RESOLUTION NO. 23-135

CHANGE ORDER

No. 6

PROJECT	Front Beach Road CRA Segment 3		
DATE OF ISSUANCE	March 9, 2023	EFFECTIVE DATE	March 9, 2023
OWNER	City of Panama City Beach, Florida		
OWNER's Contract No	2018-01		
CONTRACTOR	CWR Contracting, Inc.	ENGINEER	Dewberry Engineers

Change Order #6
Exhibit "A"

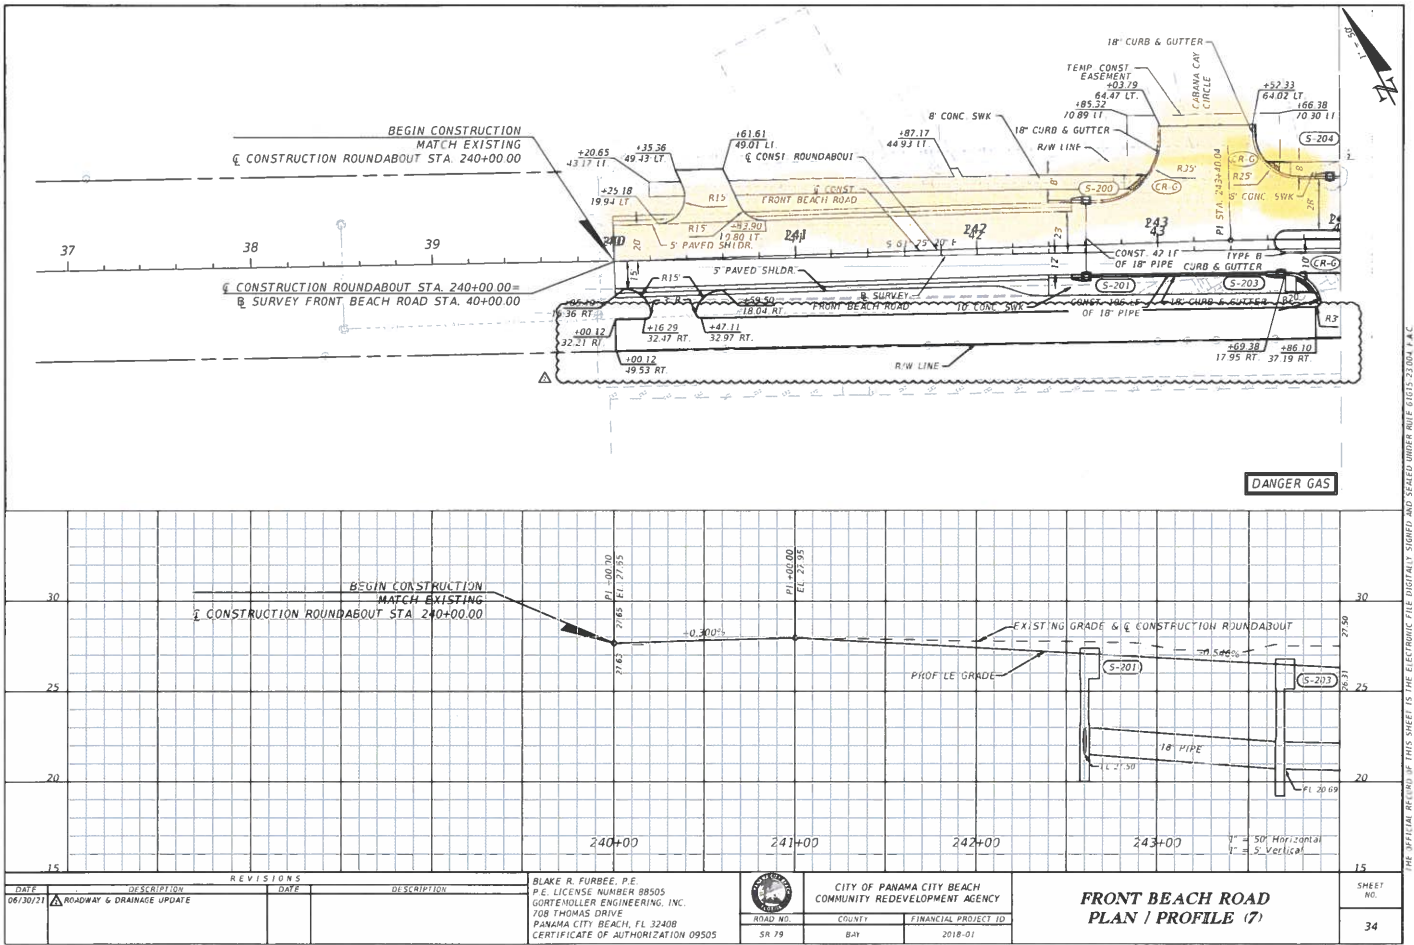
Description: 1) Create Contract Pay Item 285-704 - Optional Base Group 4

Quantity = 4840 SY, Unit Price = \$23.17 per SY

This work is authorized to allow Contractor to proceed despite failure of AT&T to timely relocate its existing telephone facilities out of conflict with mixed-in-place roadway subgrade specified in contract plans. Reimbursement for cost will be pursued with AT&T by City of Panama City Beach. All claims against City for AT&T conflicts in subgrade areas from Cabana Cay Blvd. to San Vincente Street are herein released by Contractor in consideration of this compensation and time extension.

Change in materials and method of subgrade stabilization is required to avoid damaging existing AT&T facilities that are located within the proposed mixed-in-place subgrade. Use of the original method of subgrade stabilization would result in damage to shallow AT&T facilities and cause interruption of telephone service.
